Omaha Public Power District

April 30, 1982
LIC-82-176

OMAHA PUBLIC POWER DISTRICT'S
RESPONSE REGARDING PRESSURIZED THERMAL SHOCK

FIGURE 1
CASE 4
REACTOR VESSEL PRESSURE

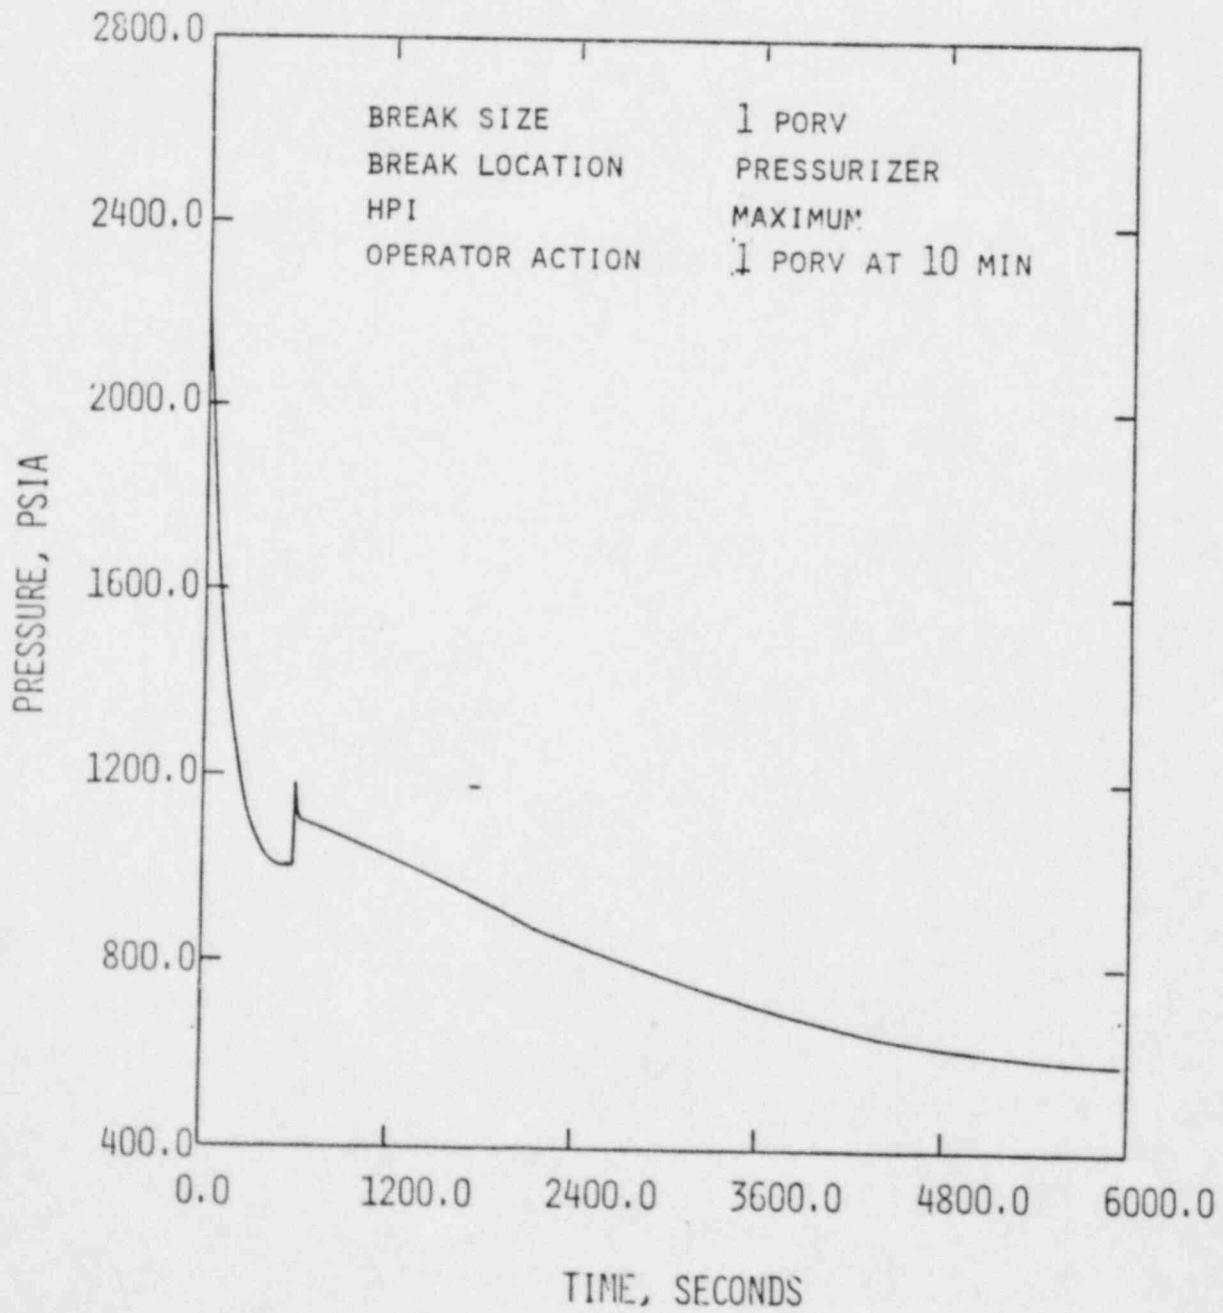
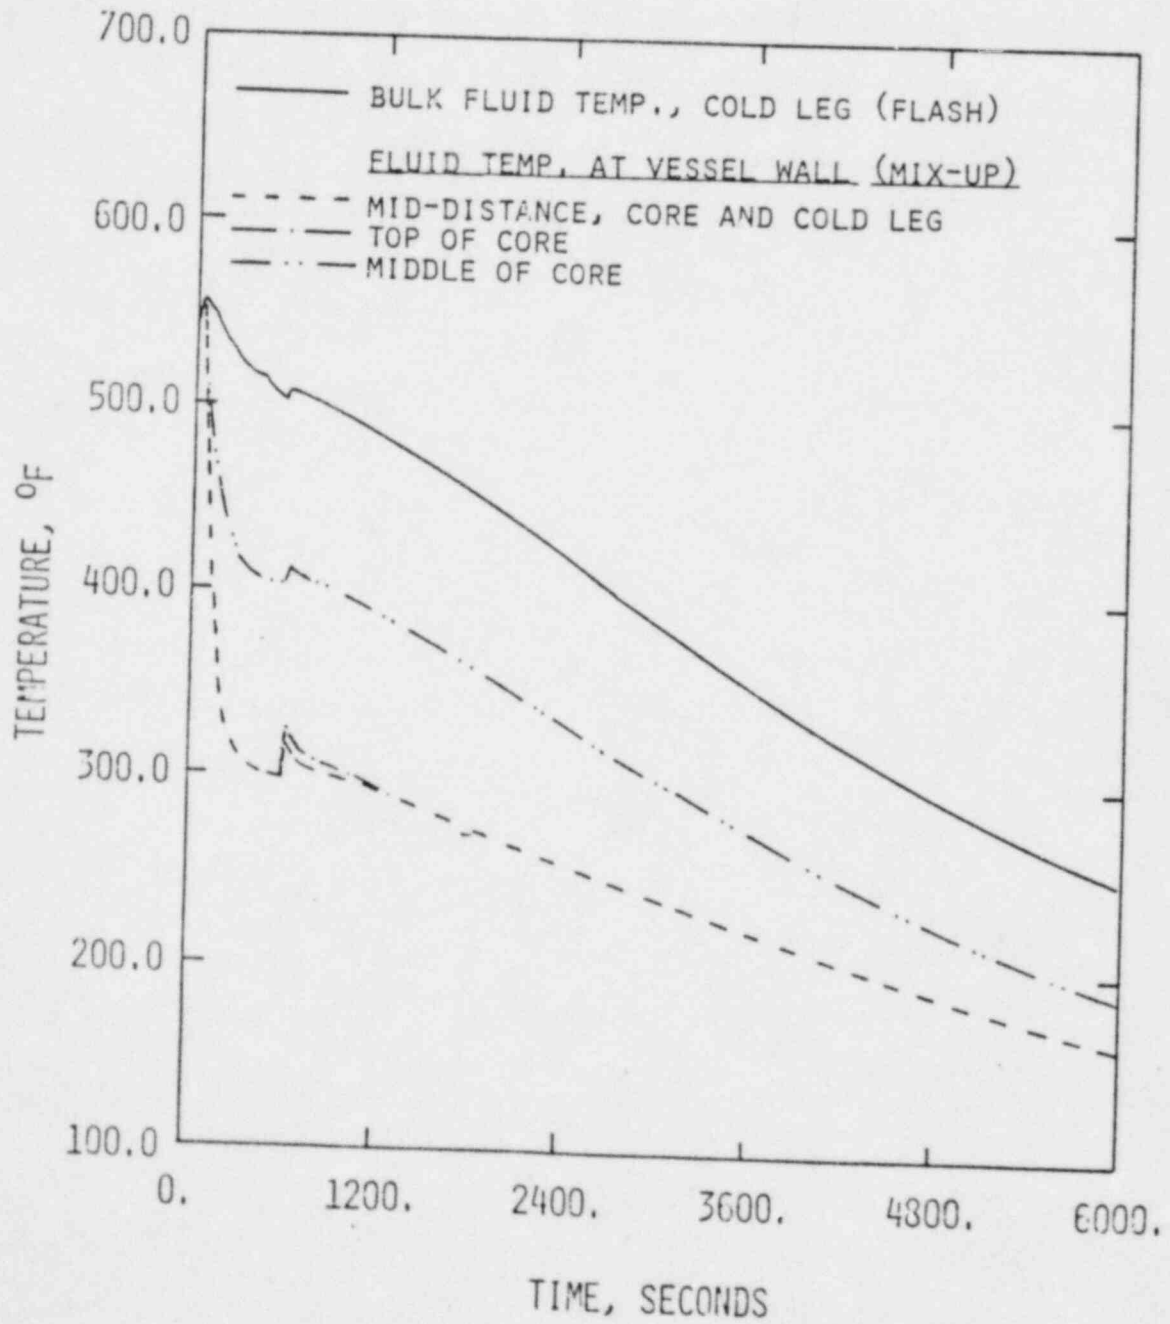
3. The Ft. Calhoun analysis took credit for warm prestressing, but stated that to preserve warm prestressing (in some cases), operator action is necessary to maintain plant parameters within pressure temperature limits. Provide an evaluation of the probability of operator error for all cases where credit is taken for warm prestressing based on operator action.

The attached Figures 1 and 2 demonstrate a slow, steady decrease of RCS pressure and temperature after the operator opens the second PORV at 10 minutes into the transient. Failure of the operator to open the second PORV at or before 10 minutes would require restoration of auxiliary feedwater at 30 minutes into the transient to maintain adequate core cooling. Case 5 in CEN-189 is the limiting case for restoration of feedwater and shows acceptable results without credit for warm prestressing. Case 5 is a more severe PTS transient compared to Case 4 without opening the PORV and restoring feedwater. Figure 3 shows warm prestressing is only credited for Case 4 after 60 minutes of the transient have elapsed. Operator actions at this time would be to continue to cool and depressurize the RCS using the HPI system and PORVs and to restore feedwater to one steam generator. If feedwater can be restored,

the operator would then lower the RCS pressure and temperature to allow shutdown cooling system initiation. If feedwater cannot be restored, the operator would establish LOCA long term core cooling to continue RCS cooldown and depressurization.

In all cases, the operator is instructed to reduce RCS pressure and temperature and is cautioned not to violate the Technical Specification cooldown curves. In the case of long term restoration of feedwater, the operator could decide to close the block valves. However, the emergency procedures are clear in their instruction to continue to cool and depressurize the RCS such that the possibility of repressurization is remote.

ANS Draft Standard 58.8 (Time Response Design Criteria for Safety Related Operator Actions) prescribes 20 minutes as the minimum time before credit can be taken for operator actions from inside the control room. To preserve warm prestressing, the operator must take action by 60 minutes to continue to depressurize and cooldown the RCS. Therefore, the District concludes that the operator has sufficient instruction and time to assure that warm prestressing is preserved.
